STAFF REPORT: 4/14/2021 MEETING

ADDRESS: 1627 (1627-1639) LEVERETTE

HISTORIC DISTRICT: CORKTOWN

SCOPE: ERECT NEW CARPORTS; REHABILITATE BUILDING

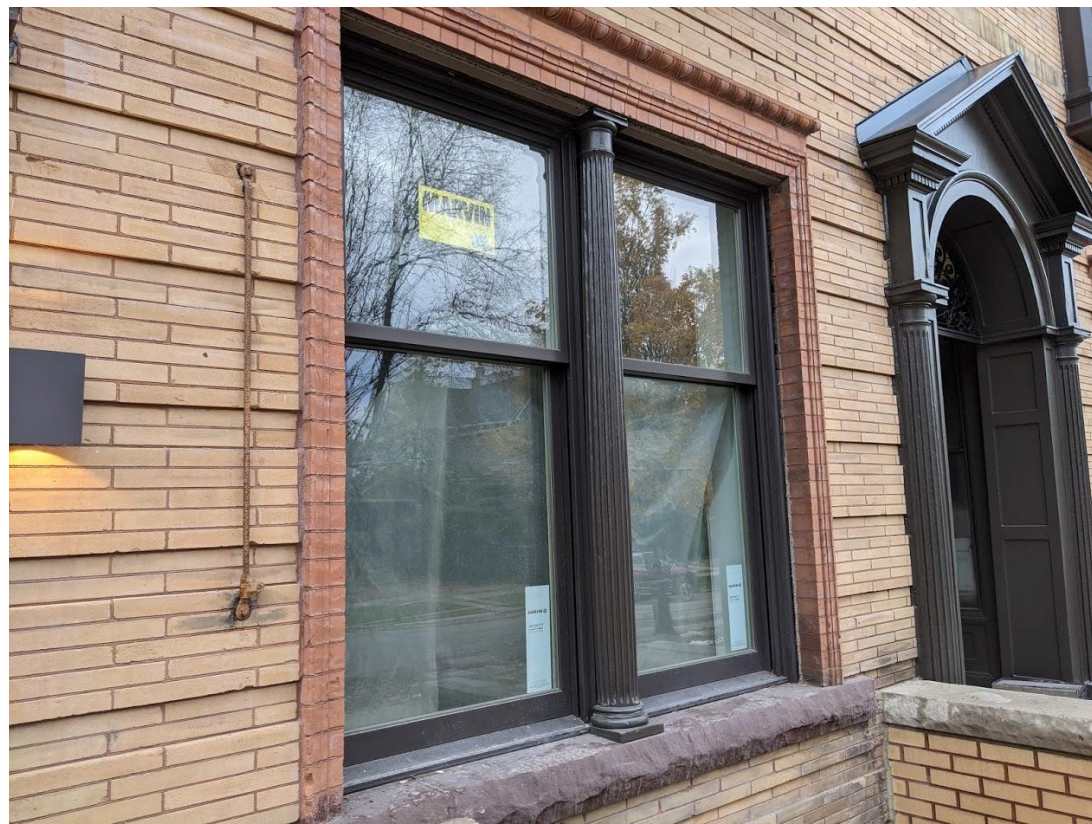
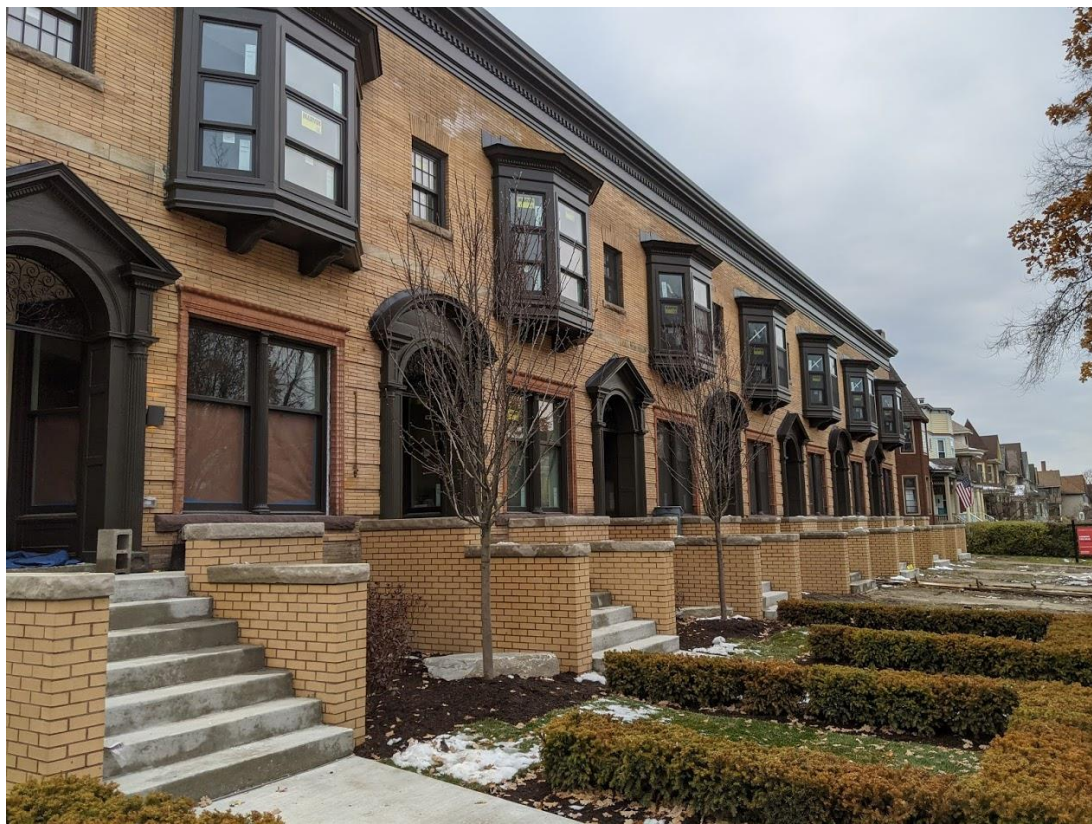
- While the new windows added in 2020 without approval are wood, they did not match the operation of the original windows at the front elevation. The current application proposes to mitigate this situation by completely replacing the windows at the second story bays with new windows to match the original in operation. The current application will also add a trim piece at the meeting rail at all first-story windows in order to better replicate the original windows.

- Each of the new transoms proposed for installation/installed at the rear elevation doorways shall be removed and replaced with a new aluminum-clad wood transom with a vision panel that better replicates the dimension/size of the original transoms.
- The newly-erected fencing, gates, rear yard walls, and rear porches cannot be unfinished. Rather, they must be stained or painted a color which complements the building. The owner or applicant shall submit a proposal to HDC staff outlining the color palette for the garages' wood elements for review and approval prior to staff's approval/signoff of the project's final construction drawings. Also, these elements must be painted or stained as per the approved color scheme on or before April 14, 2022.

Enlarged View of Existing Door Transom Opening

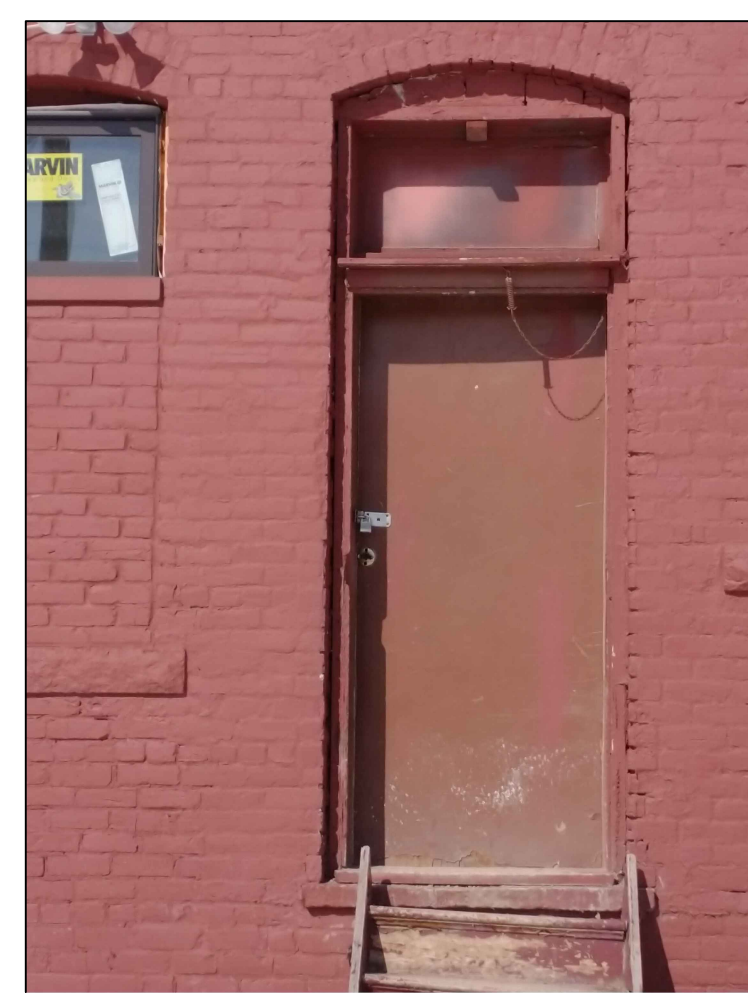
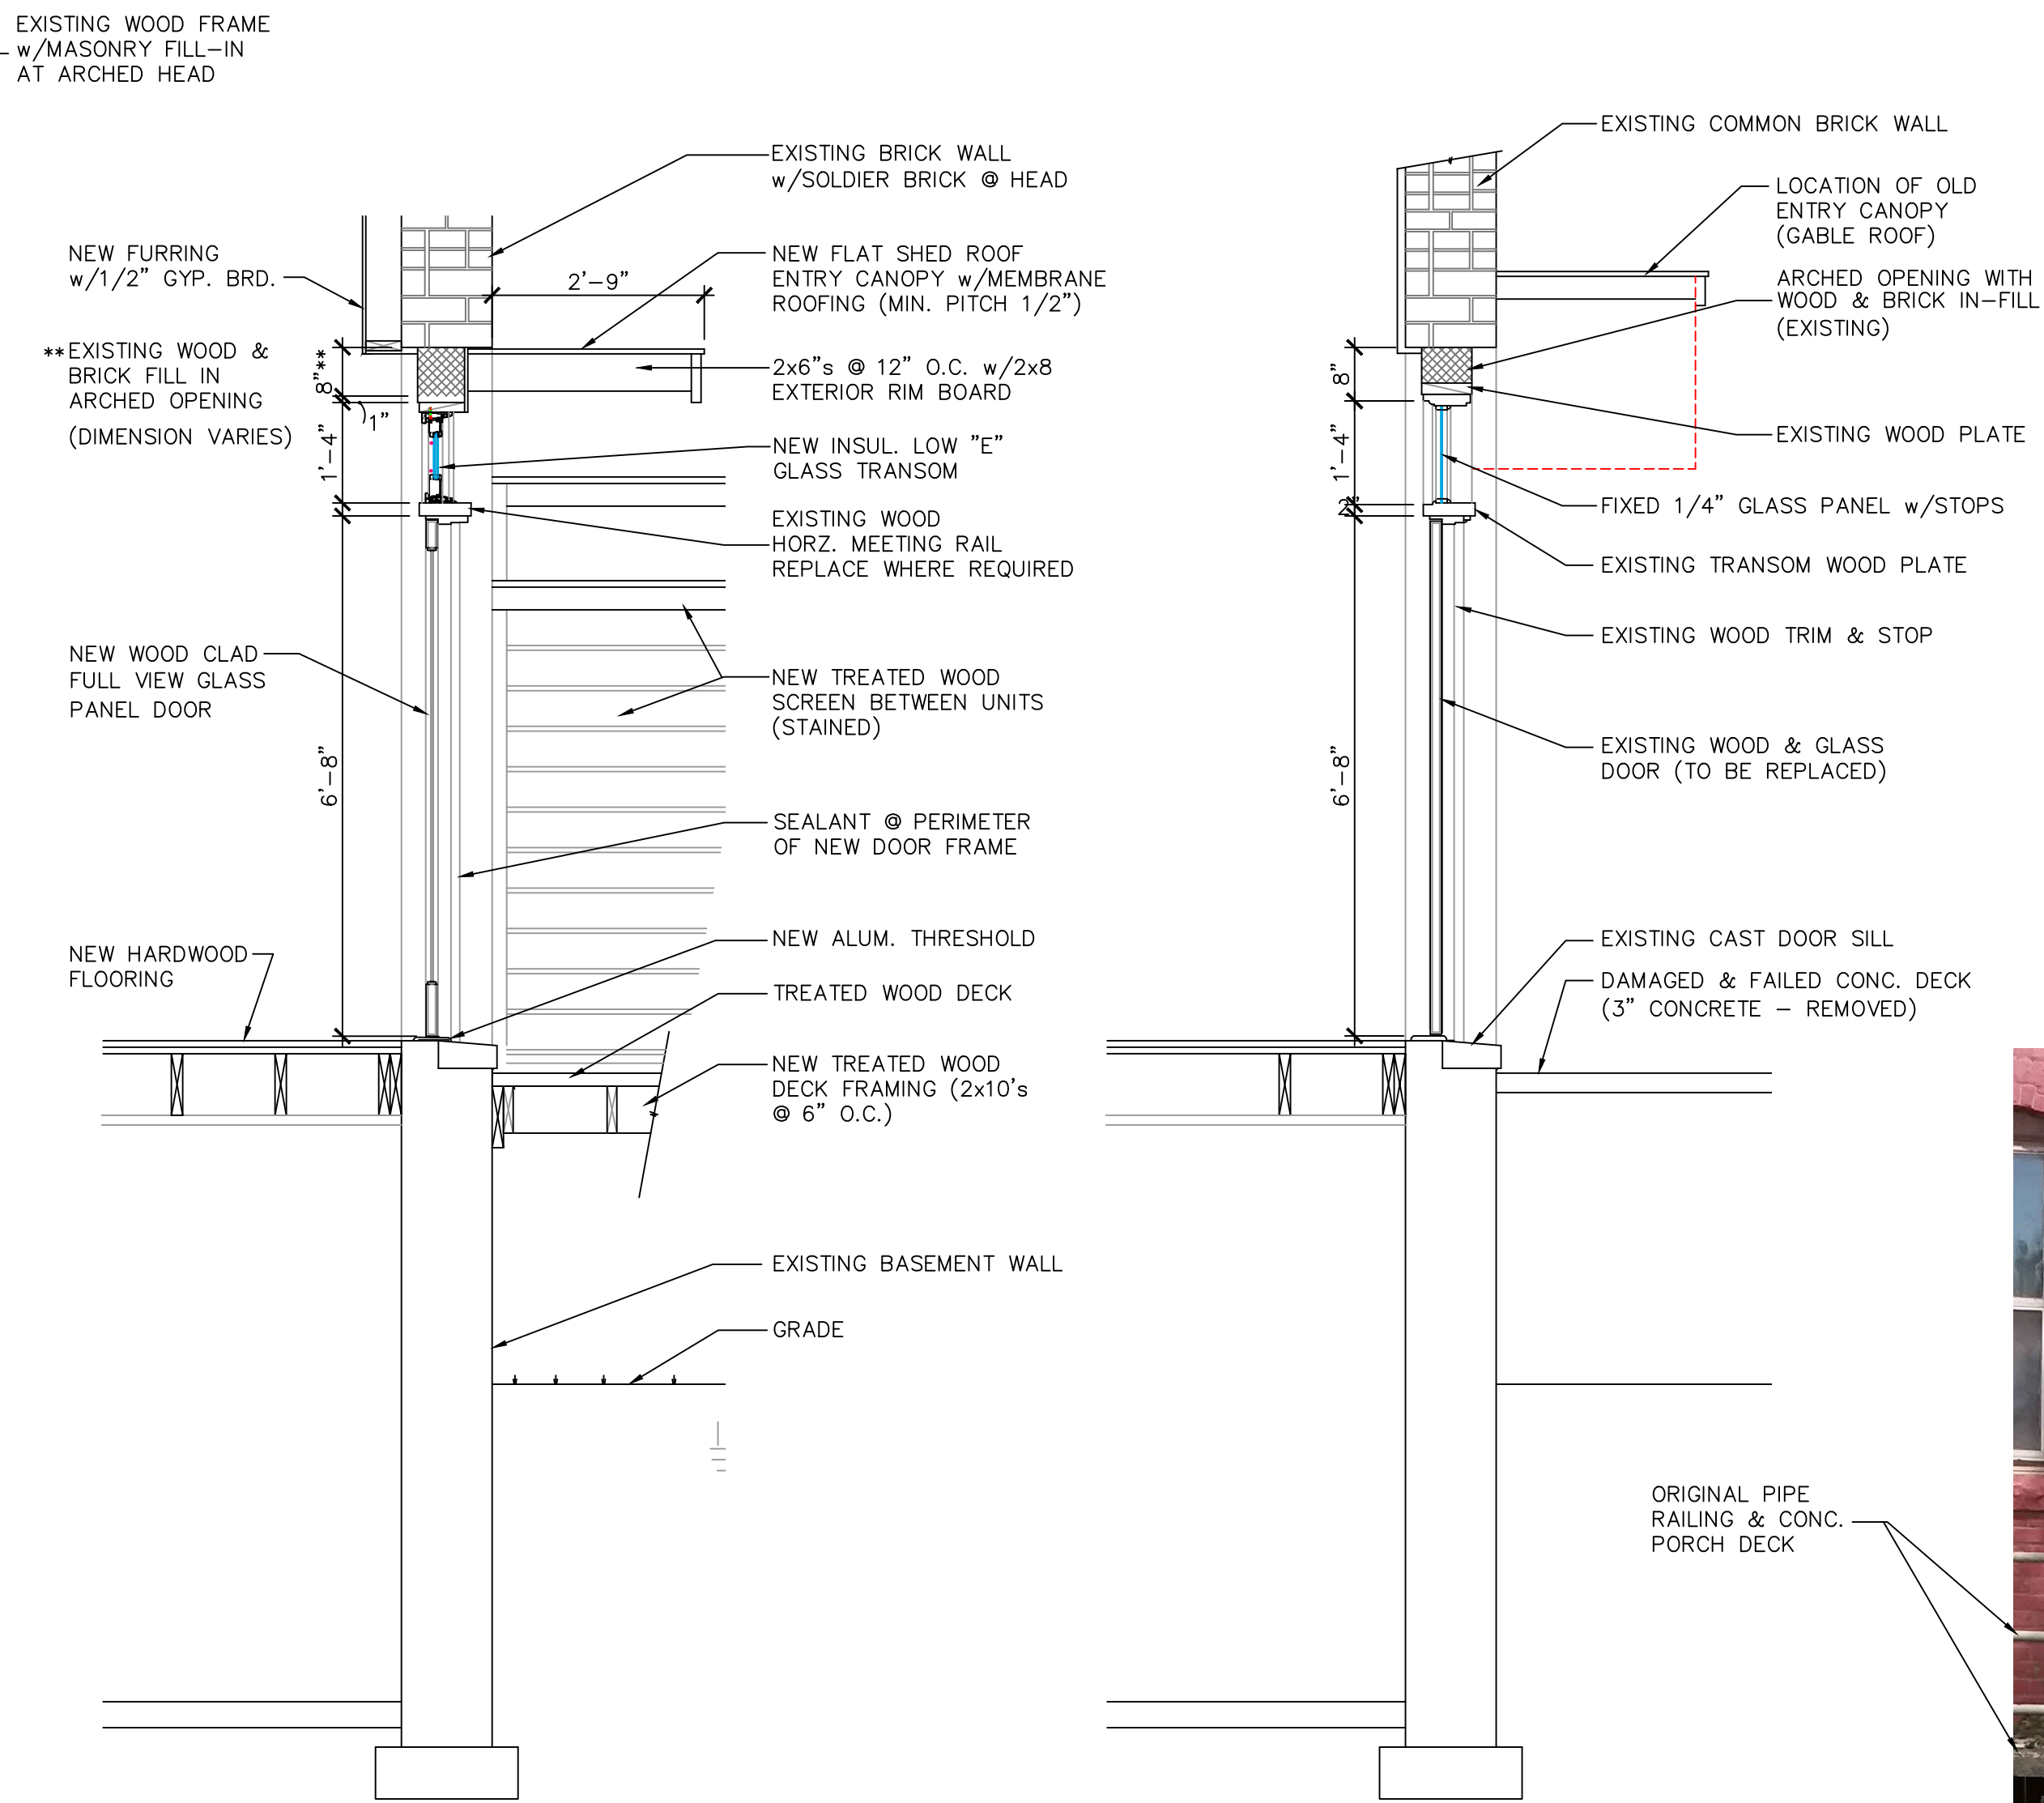
- As noted, the wood transoms over the rear doors were replaced without approval with the new aluminum-clad wood units. The new transoms are the same size, however, the amount of glass at the new transom is smaller when compared to the original because the frame is wider. However, see the photos of the original transoms. It appears that the glass at most of the transoms had been covered or removed. It is staff’s opinion that the original transoms

merited replacement. However, the new units do not adequately replicate the original due to their wide framing.

- The transoms installed over the doors at the rear elevation are not an exact replication of the original.
- As previously stated, it is staff's opinion that the windows were distinctive character-defining features at the property. However, the sash themselves did appear to be standard units with little decorative elaboration, with the exception of the pilasters at the front elevation first story which currently remain intact.
